**Full Scope Implementation of the Alternative Source Term
(661 pages)**

Westinghouse Non-Proprietary Class 3

Full Scope Implementation of Alternative Source Term

Figure 4-1 Containment Sump pH versus Time

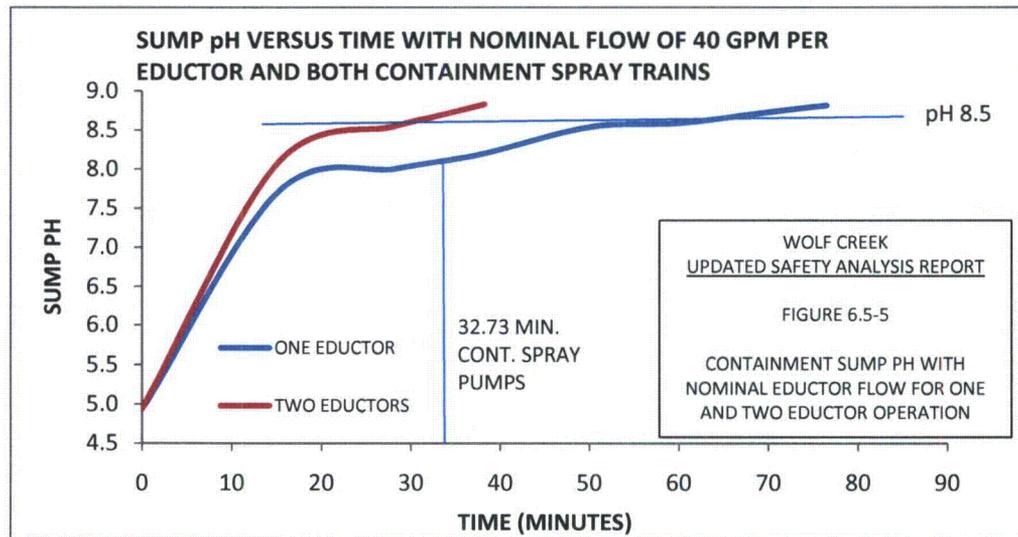
Figure 4-1 depicts the results, and is also listed as a proposed USAR markup in Section 13 to replace the existing USAR Figure 6.5-5.

Only USAR Figure 6.5-5 needs to be changed, and the USAR markup is provided in Section 13. No other USAR or Technical Specification changes are required.

Figure 4-1 shows that the acceptance criteria of 8.5 (minimum) is met for one or two eductors in service. The final sump pH of 8.8 is maintained after approximately 40 minutes after the LOCA occurs (two eductors) or approximately 80 minutes (one eductor). This result slightly exceeds the current WCGS analysis of record pH value, which is 8.6 achieved at times of approximately 40 and 80 minutes, respectively.

WOLF CREEK
UPDATED SAFETY ANALYSIS REPORT
FIGURE 15.0-30
FUEL HANDLING ACCIDENT
INSIDE CONTAINMENT

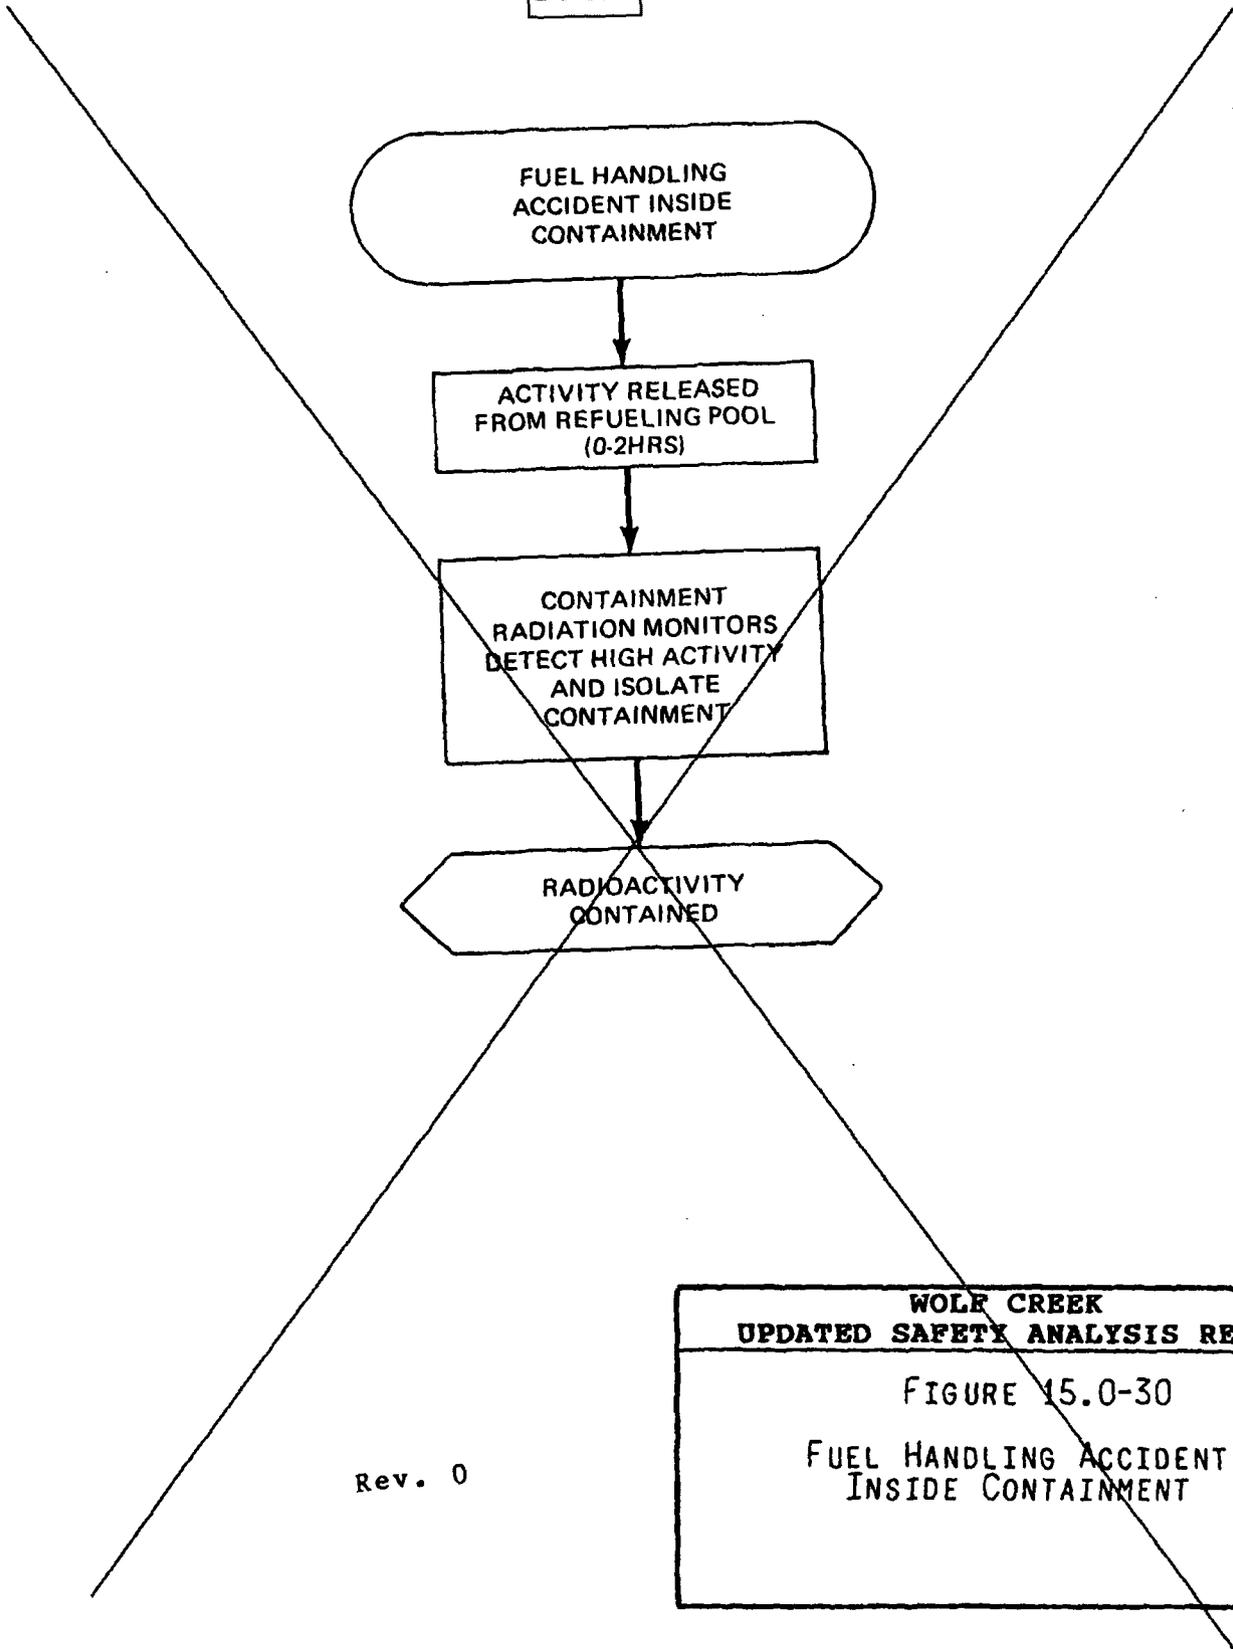
Delete

FIGURE 15.4-28

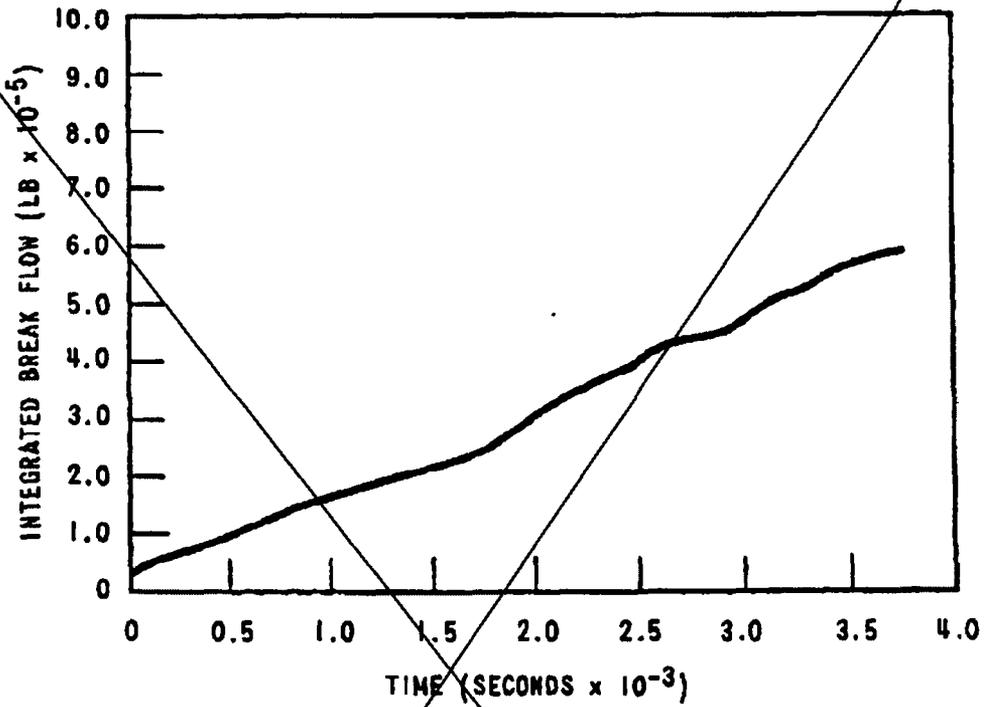
~~The RCS integrated break flow to containment following a rod ejection accident is shown in Figure 15.4-28.~~
